**TOWN OF ERIE
PLANNING COMMISSION MEETING
February 20, 2019**

SUBJECT: Dearmin Sketch Plan No. 2 - A Sketch Plan represents a generalized land use plan and layout for the area proposed to be included within a subdivision. A Sketch Plan application is required to allow for an early, informal evaluation of a proposed subdivision before detailed planning and engineering work has occurred.

PURPOSE: Planning Commission review and comment on a Sketch Plan application for 946 dwelling units and 35,000 sq. ft. of non-residential/commercial space.

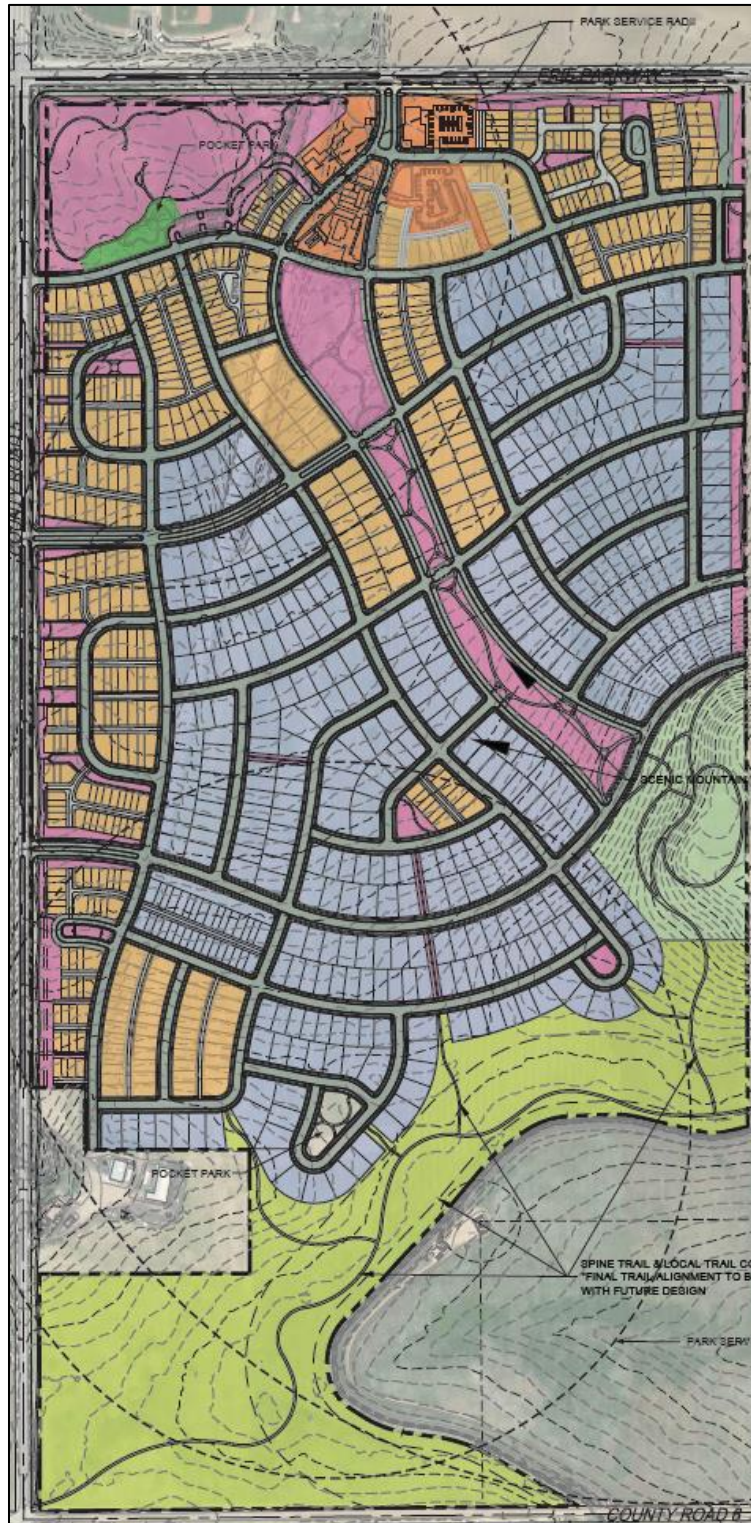
The Land Use Plan Map identifies, with a green flag, a future school site partially on the Dearmin Property. The sketch plan anticipates the required school site will be provided on the adjacent property.

Erie Parkway is shown with a cross hatched pattern over it to designate this transportation corridor as an “Area of Special Consideration”. These Areas of Special Consideration are identified to acknowledge their importance as a major community gateway and that an increased level of review and consideration should be placed on development proposal occurring within the areas identified, in terms of their uses and design. The sketch plan provides room for the required 30 foot buffer and further development review processes will address the other treatments such as development orientation, parking screening, and landscaping.
